HILLCREST RECONSTRUCTION ENGAGEMENT

WHAT WE HEARD 2: THE ROADMAP

CITY OF WHITEHORSE
ENGINEERING SERVICES

JUNE 14, 2023

3.2.2 OVERVIEW MAP

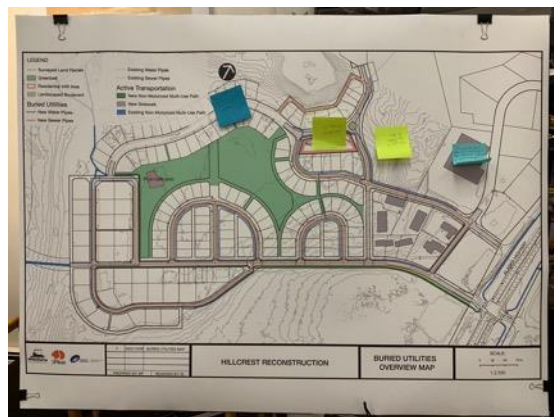
A lot of positive feedback was received with positive feedback on the overview map. Some of the participants noted some opportunities for improvement too. Summaries of what we heard are provided below, with clarifications in square parentheses (i.e., [...]).

- Concern about cyclist safety and driveway crossings [Path Concept on the South side of Hillcrest Drive West].
- A question about a potential rack to lock up bikes at the bus shelter. [at a bus stop on Hillcrest Drive near Dalton Trail].
- Support for putting a path on the north side to reduce the need for a crossing of the airport access road.
- The desire for improved transportation options around the gas station.

3.2.3 DETAIL MAP 1: SUMMIT & ROUNDDEL

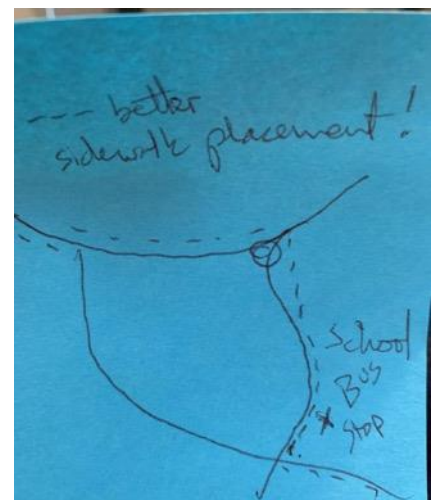
- Do not remove the existing “roundabout” on Summit Road.
- Most of the properties in Hillcrest have a buffer trail / green zone at the back. As such, there should be a similar trail or green zone applied to the infill area [pointing at the infill area].
- Support for low-density in the infill area.
- School bus stops for 4 or 5 busses twice daily on (the east side) [see post-it below]. It would be awesome to have some sidewalks on the east / north side (forest side [of Roundel / Summit] rather than up against fences).

- No roundabout.
- Concerns that Roundel would not be wide enough to accommodate sidewalk and vehicle parking in front of apartments.
- Replace the roundabout with a T intersection on Summit Road.
- Modify the right of way near the proposed roundabout by lot 130 to allow good road alignment.

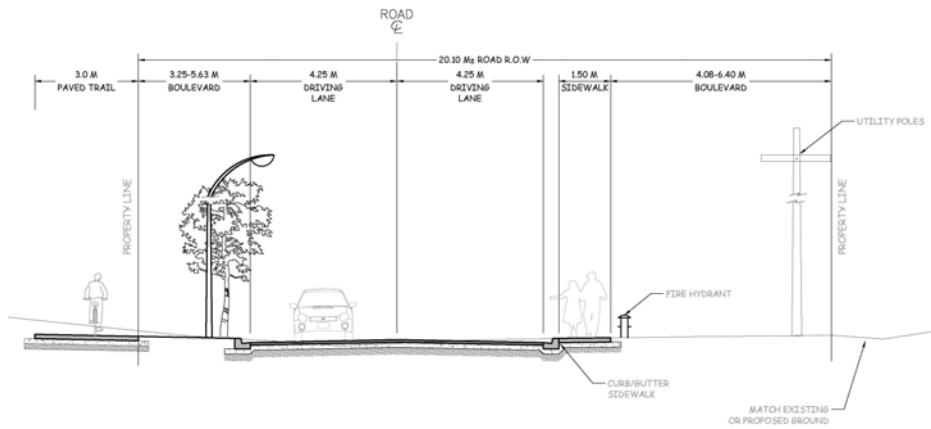
Hard to tell from this drawing. I like that the bike lanes away from the cars.

Generally good - but managing the crossing at the west end will be a challenge - why not just have the shared track on the north side, remove the sidewalk? This removes a hazardous crossing of downtown, and saves money

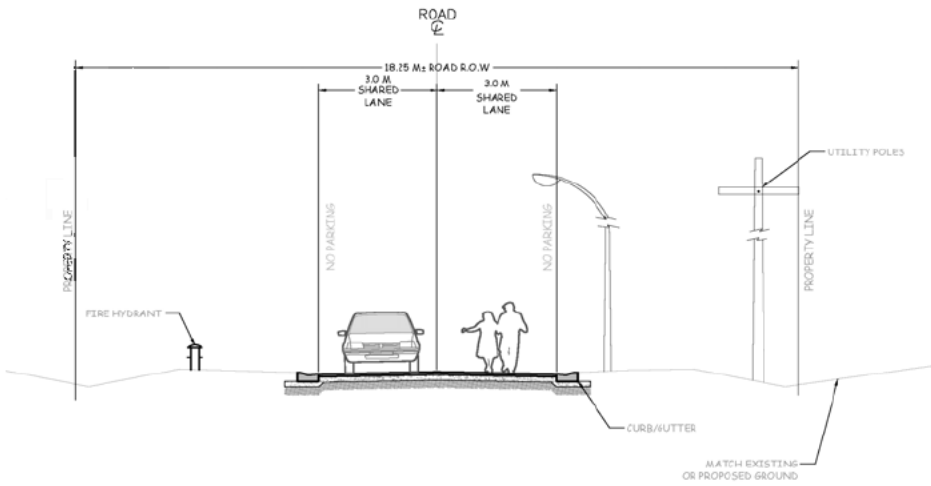
- Anonymous
12/19/2022 11:32 AM
I am happy with the design - am glad there's no sidewalk being added
- Anonymous
12/19/2022 07:21 PM
People often need extra parking space and use the road. Making this a no parking zone may cause frustration.

- Anonymous
12/20/2022 04:38 AM
Is this the same plan for sunset south.
- Anonymous
12/20/2022 02:20 PM
Personally we are going to manage our vehicles so we won't be street parking, but what about visitors and multi-family homes. The street parking has increased a lot since we first started planning our street upgrades. More multi-family homes.

What about s dewa ks? If there's no on-street park ng, sn't t obv ous that peop e w cont nue park ng on the bou evard? On-street park ng s essent a when hav ng peop e v s t, or for fam es w th teenagers w th cars. Th s proposa has to change.

Need before and after x sects to understand the changes. Do a res dents now park on own property? What about v s tors? Why are ut ty corr dors so w de? Does c ty nsta cu verts under dr veway access? Is K uane recentered?

What s the v s on of where peop e w park on th s street g ven that there s no street park ng. How w the C ty manage th s?
